Naperville Data Center Site – Response to Comment (RTC) 1960 W. Lucent Lane, Naperville, IL 60563

RE: Response to Comments from Proposed Data Center Noise Impact Assessment

1960 W. Lucent lane, Naperville, Illinois 60563

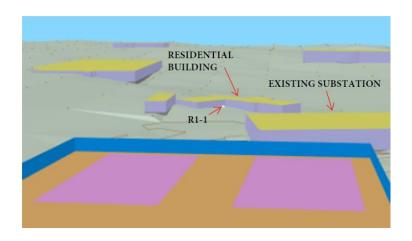
"Please confirm that the 'auxiliary' building representing the substation is accurate size and shape in SoundPlan to ensure accurate shielding effects"

The existing substation building and walls shielding the R1-1 receptor from property-line noise sources is set at 19 feet in total height. The corners of the building/walls are set into the ground slightly. Though the height is variable above ground given the variation in grade, the height near the corners of the wall nearest to the R1-1 receptor are approximately 16 feet in height. Since most of the noise impact at R1-1 is from rooftop HVAC units, and the substation does not break line of sight from the top of the parapet wall with the current receiver location. The shielding effects of the substation walls are not significantly effective in reducing noise propagation from the proposed data center noise for the current Leq-N model (Figure 4 on the NIA). A 3D image of the line-of-sight between the rooftop parapet and Receiver R1-1 is provided below for visual context.
